PDP-8L

TECHNICAL INFORMATION

Engineering Change Order Log

ECO SYNOPSIS FOR LOGIC OR OPTION

ECO # 8L-00090 D-BS-8L-0-11 NEW REV. B

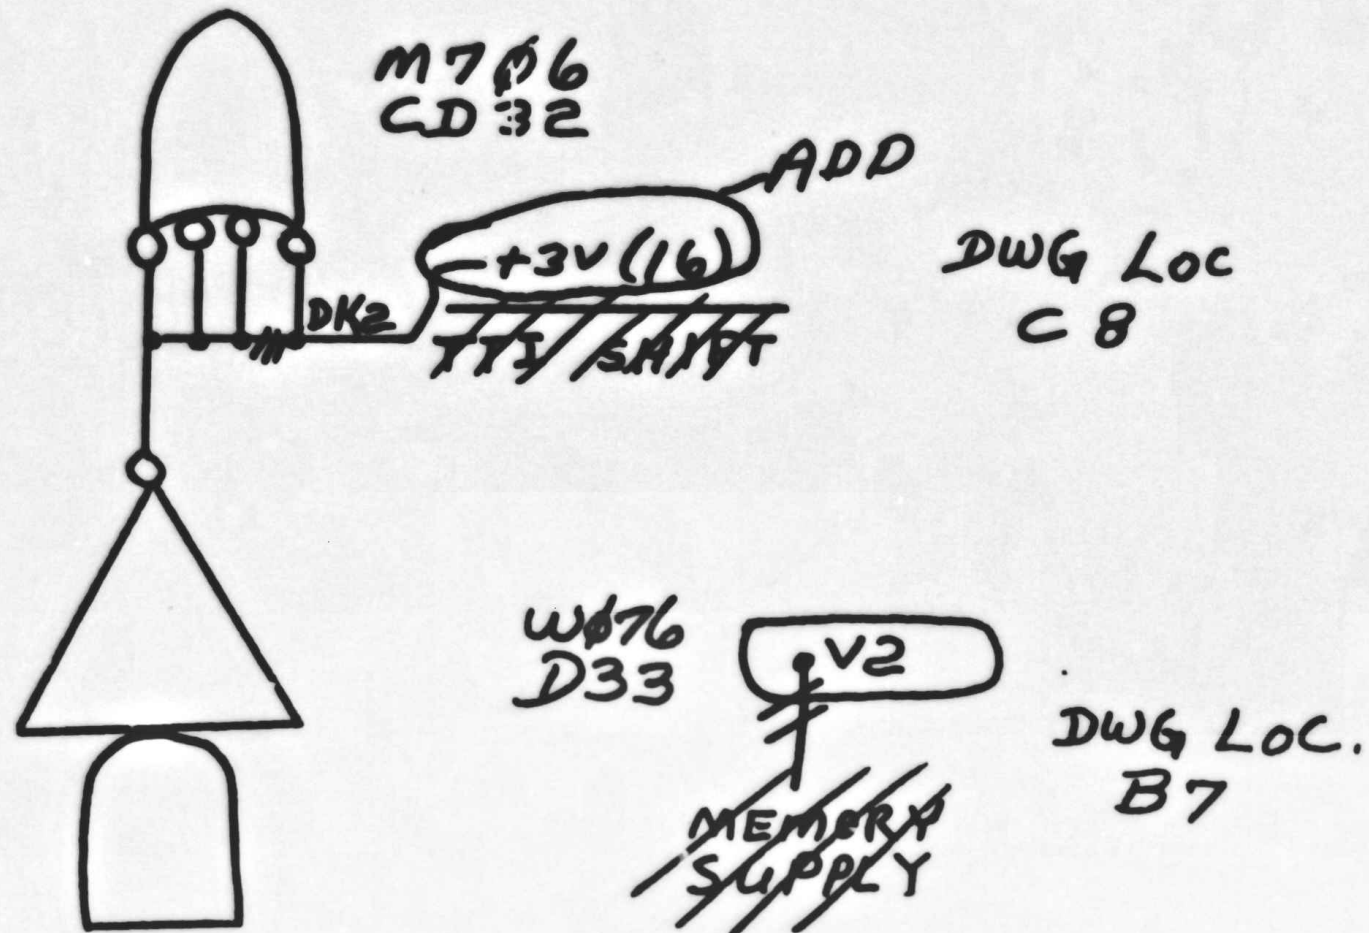
BL 00090	BL 100-2516>	F	JAN 70 - TIES A FLOATING LEG OF THE M706 AT CD32 TO +3 VDC AND REMOVES -3 VDC FROM THE W076 CONNECTOR TO ELIMINATE RANDOM FAILURES WHICH OCCUR WHEN AN EXTRA CHARACTER IS ADVANCED. THE PROBLEM IS ESPECIALLY NOTICEABLE WITH TELETYPE TEST, PART 2, TEST 3.
BL 00091	BL 2597> RETROFIT IF POSITIVE BUS OPTIONS ARE INSTALLED	F	FEB 70 - ADDS A G717 PULSE TERMINATOR MODULE TO THE BL PARTS LIST SO THAT IT WILL BE AVAILABLE WHEN OPTIONS ARE ADDED TO THE BL I/O BUS. (*\$5.00, **\$4.00, ***10.00)

ECO #8L-00106 A-PL-8L-0-18 NEW REV L

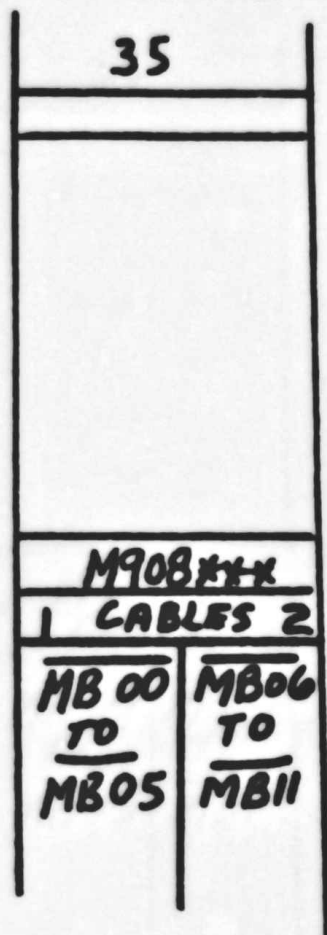
ADD TERMINATOR BOARDS M902-YA FOR THE MB BITS AND M902-YB FOR THE AC BITS.

:::: THE ~~G11~~ ^{ADD} M902-YB (TERMINATOR) IS ALWAYS PLACED AT THE END
 OF THE IO BUS FOR IOP'S, ^{ADD} AC BITS AND ~~ADD~~ TIME STATES WHEN
^{ADD} 20 FEET OR MORE OF CABLE IS USED. WHEN THERE ARE NO
 OPTIONS THE ~~G11~~ ^{ADD} M902-YB IS PLACED IN LOCATION D36.

Title					Tech Tip				
8L AFFECTED BY EXTERNAL NOISE					Number PDP8L-TT-7				
Processor Applicability					Author W. Freeman				
All					Rev g				
8L					Approval W. E. Cummins				
					Date 11/14/73				
					Cross Reference

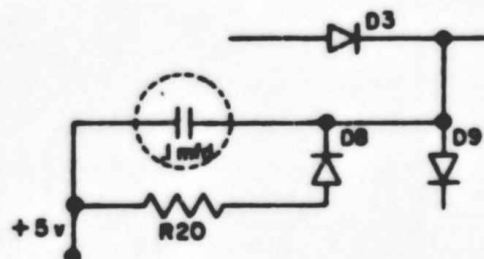
If external noise from surrounding equipment is affecting an 8L, the installation of a .1 mfd. capacitor on the G785 module as shown in the schematic below will resolve the problem.
